Town of Hilton Head Island
Design Review Board Meeting
Tuesday, December 13, 2022 – 2:30 p.m.
AGENDA

PLAN CORRECTIONS REPORT DRB-002893-2022

PLAN CORRECTIONS REPORT DRB-002892-2022

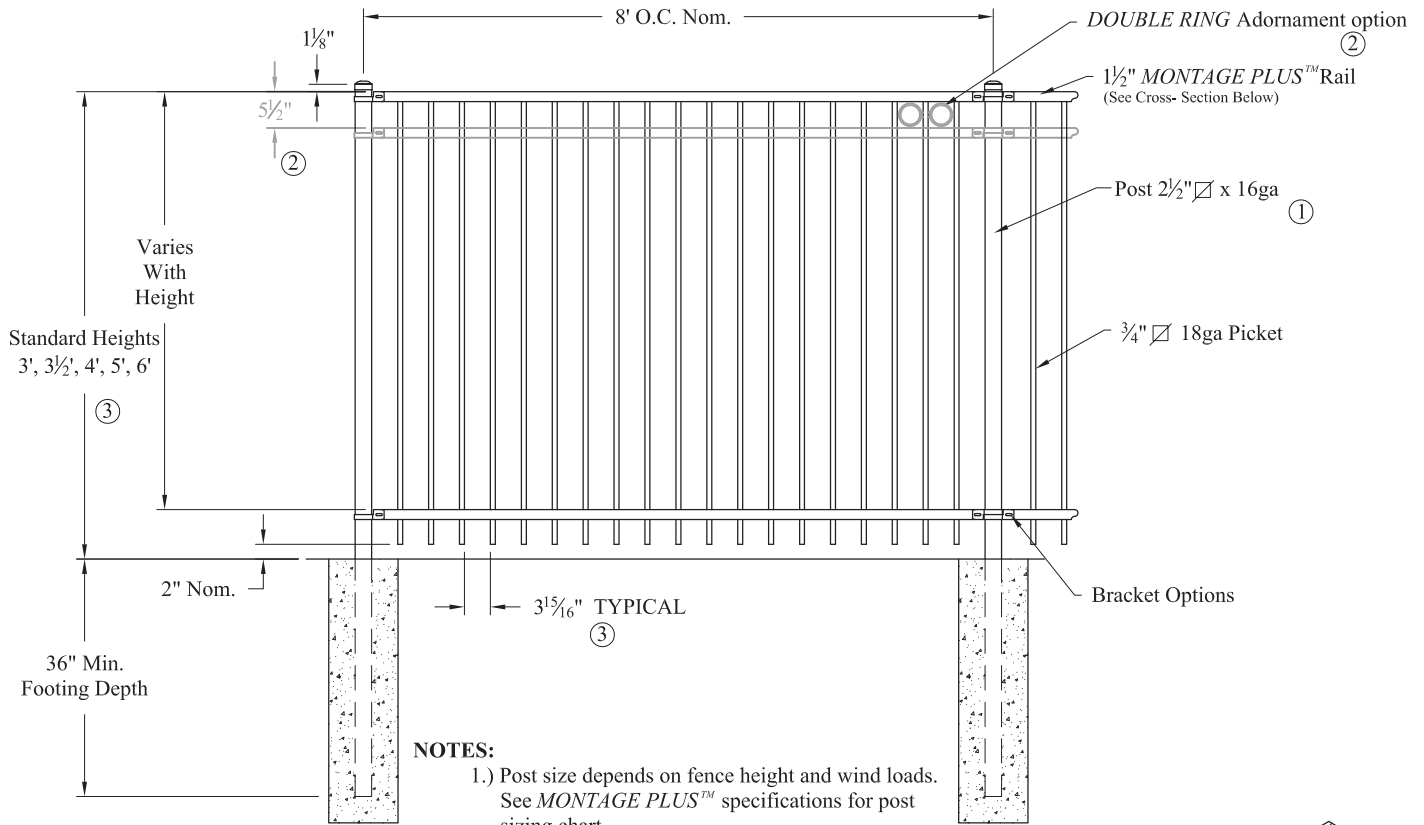
1. Increase the following plant sizes:
 - a. Magnolias to 2" caliper and 10' ht.
 - b. Yaupon Holly to 15 gal.
2. Revise the tree protection detail to include rigid horizontal plank.
3. Specify the color of the bike rack to be bronze.

3 CLUBHOUSE - REAR ELEVATION
 A-3.0 SCALE: 1/4" = 1'-0"

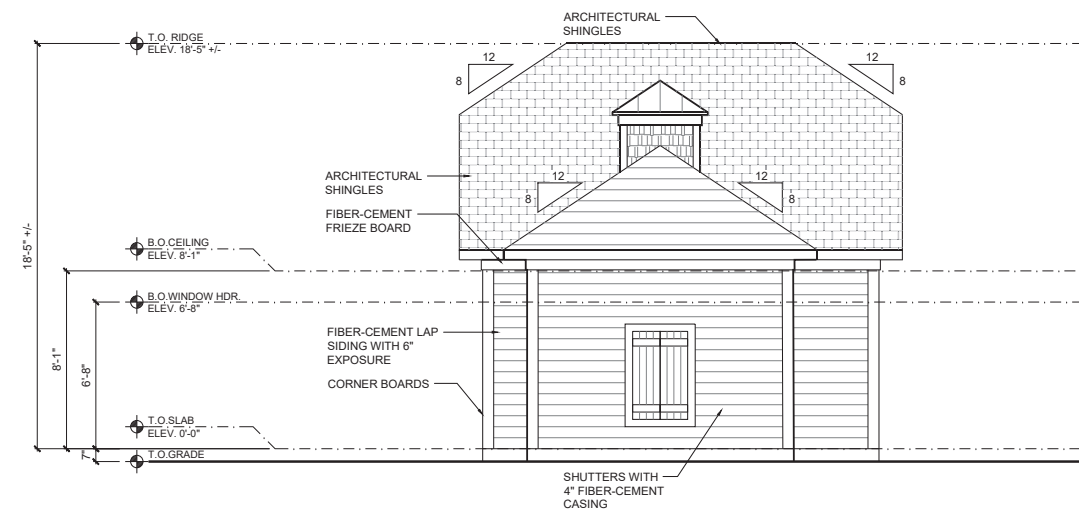
7. For consistency on the rear (poolside) elevation: add shutter treatment to the blank walls, specify a door treatment or color to better blend with the wall.
